## TECHNICAL SERVICE BULLETIN

**TSB D-PC-0042**

**Date:** March 4<sup>th</sup>, 2024  
**To:** Internal, Sales, Distribution, and Sales Representatives  
**From:** Technical Service Department  
**Subject:** WattMaster DDC Controls Warranty Replacement 3 -25 Ton DC Models

**Image 3**

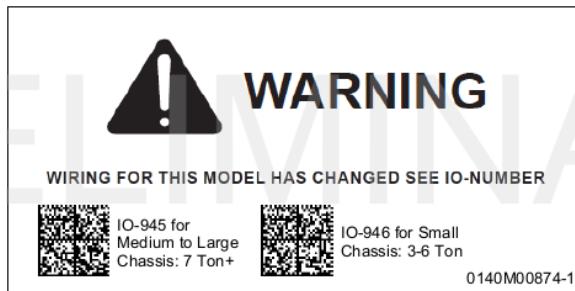
**A label is included in the kits that must be applied next to the wiring diagram on the unit for future service requirements. This label provides installation and operation information for the kit due to the wiring changes (Image 3).**

I&O Small (3-6 Ton)	I&O Large & Medium chassis (7.5-25 Tons)
IO-946	IO-945
